CITY OF ALBUQUERQUE

March 26, 2018

RE: **5304 Camino Abustos NE**
Grading Plan
Engineer's Stamp Date 3/15/18
Drainage File: F22D015D

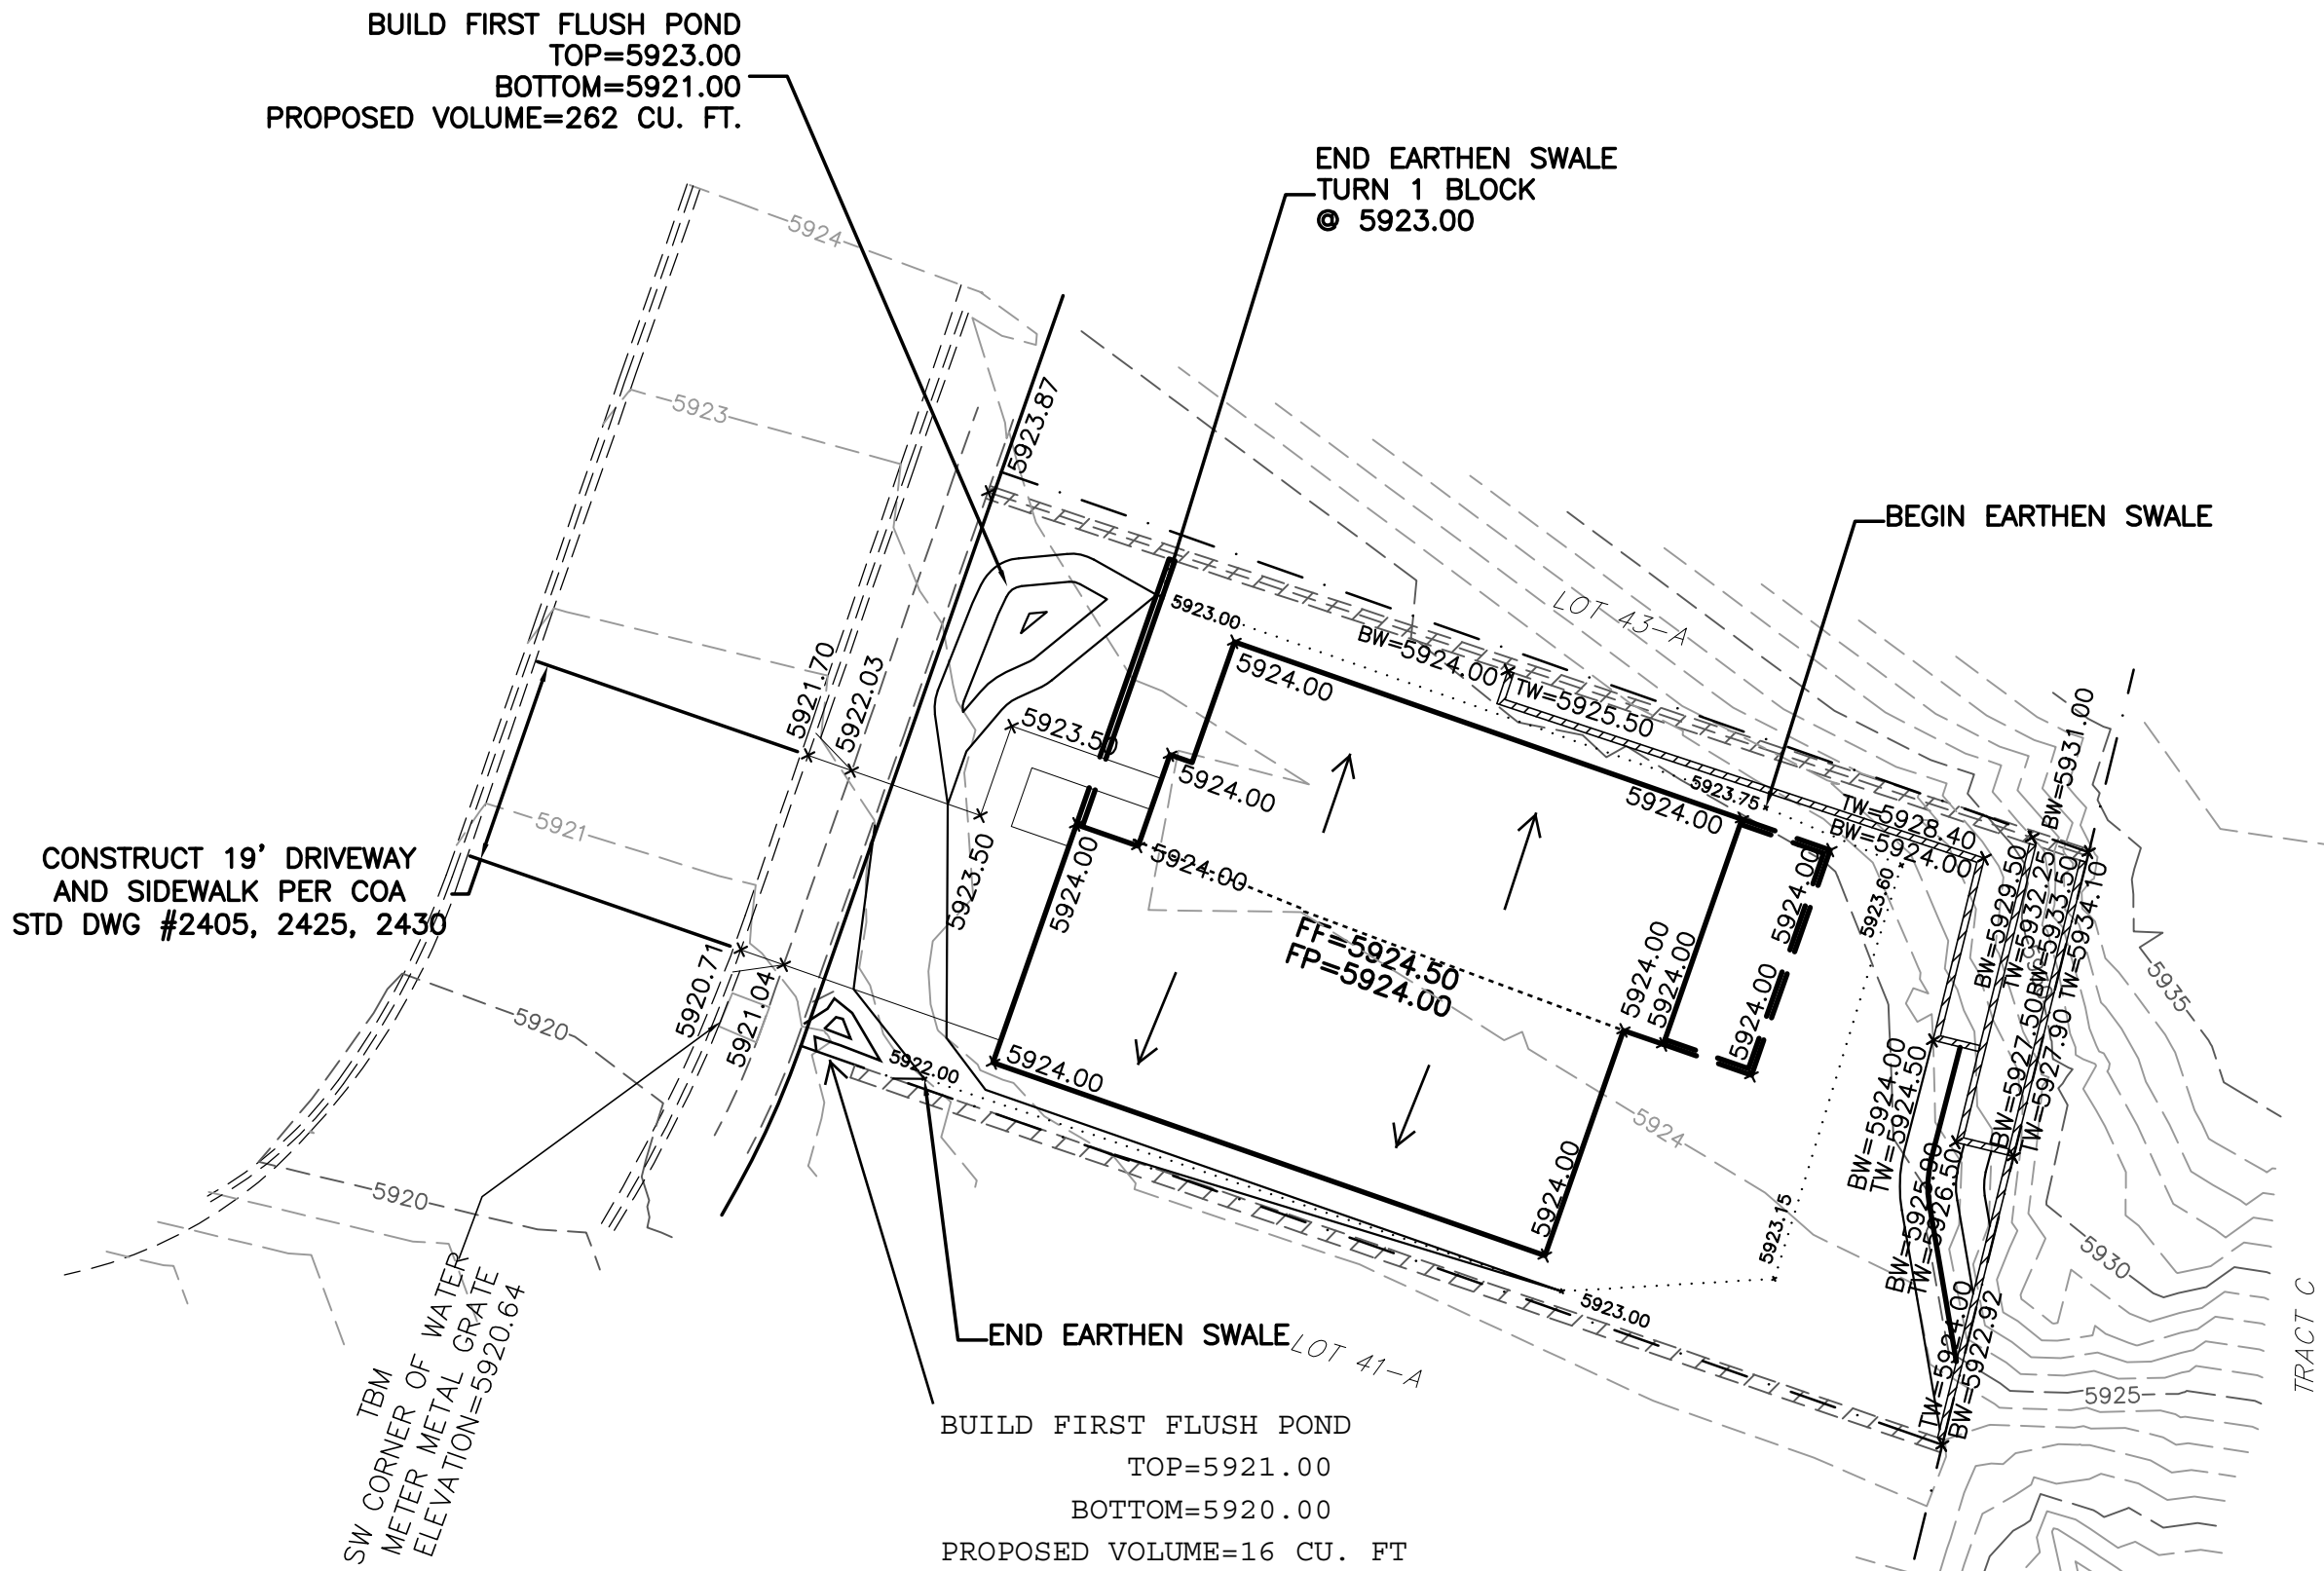
Based on the information provided in your submittal received 3/15/18, the grading plan is accepted for information only. This residence is within the approved subdivision grading plan for F22D015 (BHI, 1979) and does not appear to differ significantly from this subdivision plan. Therefore, the site grading plan does not need to be approved separately by Hydrology.

A wall permit will be required for the new retaining walls and should include this site grading plan. Please ensure all retaining walls and their footers are shown within the subject property, unless written permission has been obtained for a common wall.
